Subject: Westinghouse Response to Requests for Additional Information (RAIs) on
WCAP-17577, Rev. 1

WESTINGHOUSE TOPICAL REPORT REVIEW

RAI Response Number: WSTM-007-NP
Revision: 0

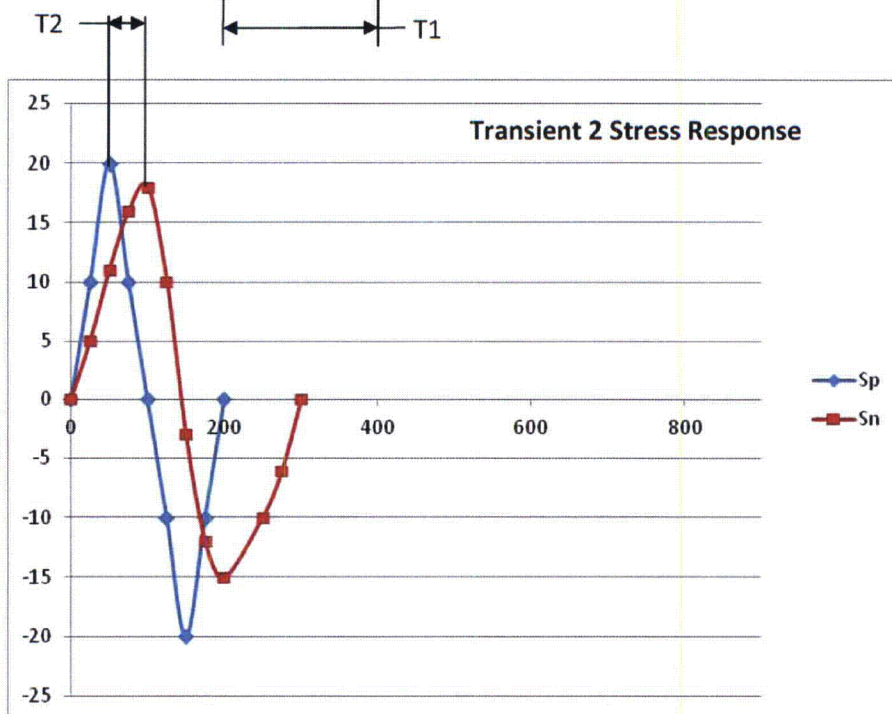
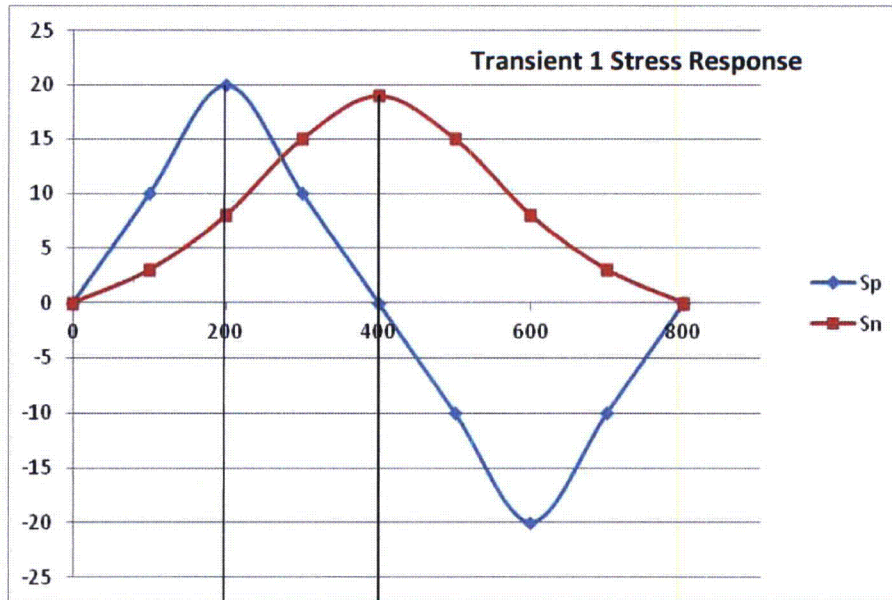
In Figure 4-4 of WESTEMS TR, the time constant check process is for eliminating redundant peaks/valleys. The staff is requesting the applicant clearly define how the time constant is determined and provide clear justification/criteria for this elimination. Since the time constant is applied to all transients in the analysis, any wrong definition will cause the actual peaks/valleys to be deleted. For example, a standard reactor coolant pressure boundary component subject to 30 or more transients. Use one constant time number to fit 30 transients does not appear to be justified. This information should be summarized in the topical report.

characteristic of the peak selection methodology is that the thermal stress contributions to S_n and S_p can be separated by a period of time. For example, the thermal discontinuity stress will typically maximize later than the shock stress due to a given load excursion. Both types of thermal stress are included in S_p , but only thermal discontinuity stress is included in S_n . Therefore the S_n peak time can lag the S_p peak time in response to the same load excursion. This phasing of the S_n and S_p stress histories can result in different S_n and S_p peak times being selected in response to the same transient load excursion.

As an example, Sn and Sp plots are shown below for two representative transient cases. [
